WAMBO COAL PTY LTD

Attention: Mr Gordon Kirkby, Chair for DA 305-7-2003 MOD 17

RE: WAMBO COAL MINE MOD 17 – CLIFF LINE PERFORMANCE MEASURE

Location of Cliffs Relative to MOD 17 Longwalls

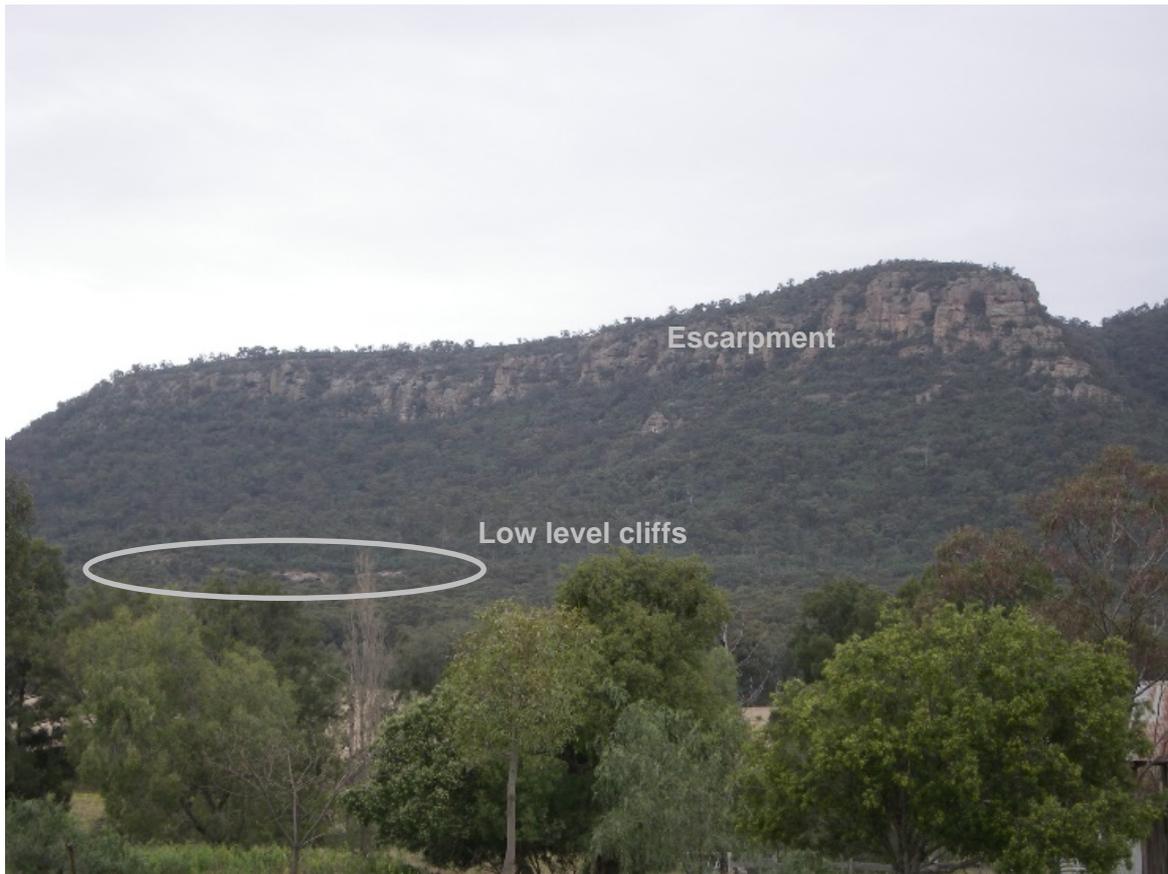
The low level cliffs (cyan hatch in attached figure) are located near the bottom of the steep slopes above the south-western ends of the proposed Longwall 20 and Longwall 21. These cliffs have heights varying between 10 and 15 m and are generally discontinuous.

The total length of the low level cliffs located above the proposed longwalls is approximately 150 metres, with a face area of approximately 2,000 m².

- are located on Wambo Coal-owned land and therefore any rock falls would not present a public safety risk;
- are not visible from public land and therefore any rock falls would not have a visual impact; and
- are less significant than the larger cliffs along the escarpment that are located outside the angle of draw of the longwalls.
